TSB-94-26-9

1992-94 CROWN VICTORIA
1994 MUSTANG, THUNDERBIRD

ISSUE:

Figure 1 - Article 94-26-9

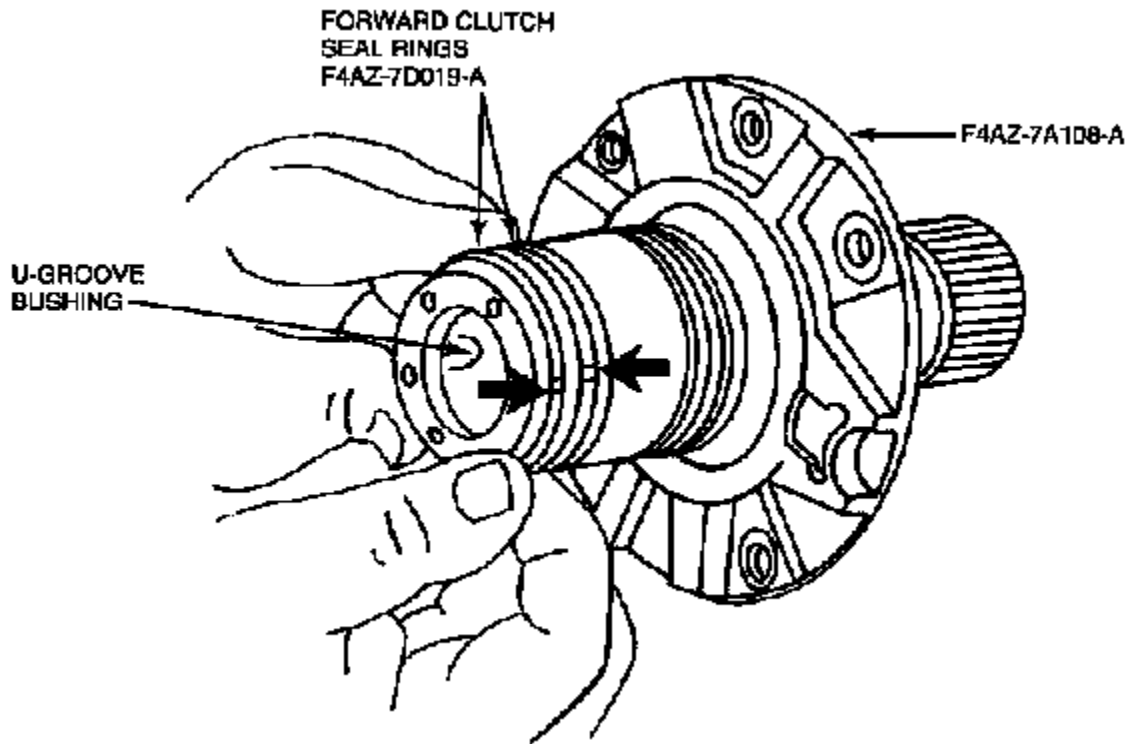
- A cross leak between the forward and reverse clutch circuits in the main control during high engine speeds in reverse (e.g., 3000+ RPM for vehicles stuck in snow, sand, mud or other similar conditions).
- Wear of the Stator Support Rear Bushing causing wear of the #4 Seal Ring and resulting in Forward Clutch and/or Overdrive Band damage.

1. Inspect the #3 and #4 seal ring area and the rear bushing on the Stator Support (Figure 1).

2. Replace the Stator Support with a new Stator Support (F4AZ-7A108-A) which has a rear U-groove bushing.

THIS STATOR SUPPORT MUST BE USED WITH #3 AND #4 ID/OD CHAMFERED CAST IRON SEAL RINGS (F4AZ-7D019-A).

Figure 2 - Article 94-26-9

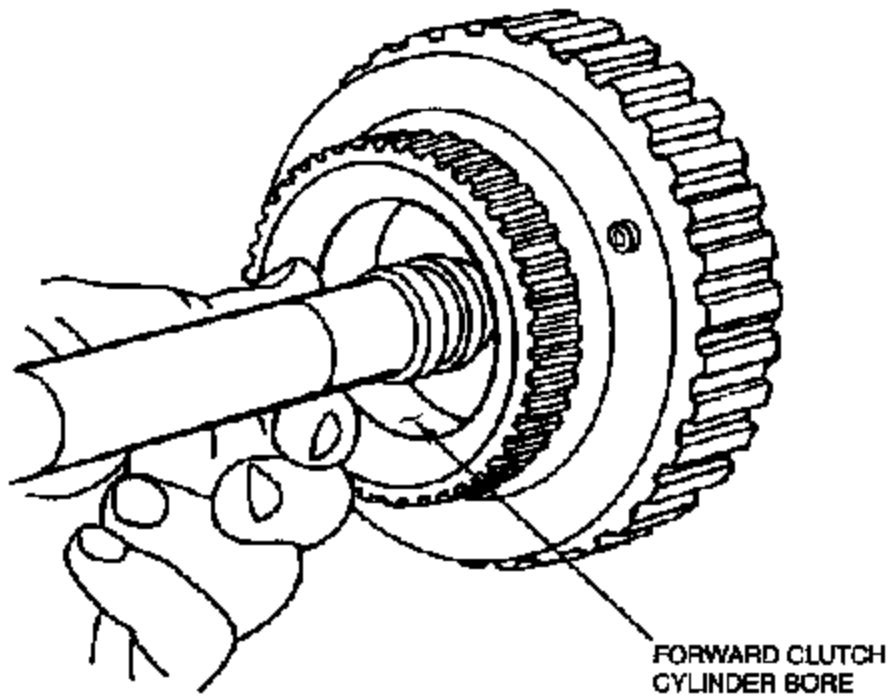
3. Inspect the mating area of the Forward Clutch Cylinder and Input Shaft Assembly (Figure 2).

4. Replace the assembly if the area is grooved or shows an indication of excessive wear.
5. When the main control is removed for service, check the large valve body reinforcing plate. If it is the original plate (0.140" (3.5mm) thick and no I.D. notch on the edge) install a main control reinforcing plate service kit (F4AZ-7F282-A) (Figures 3 and 4) and perform normal repair procedures. Refer to the following for kit contents.
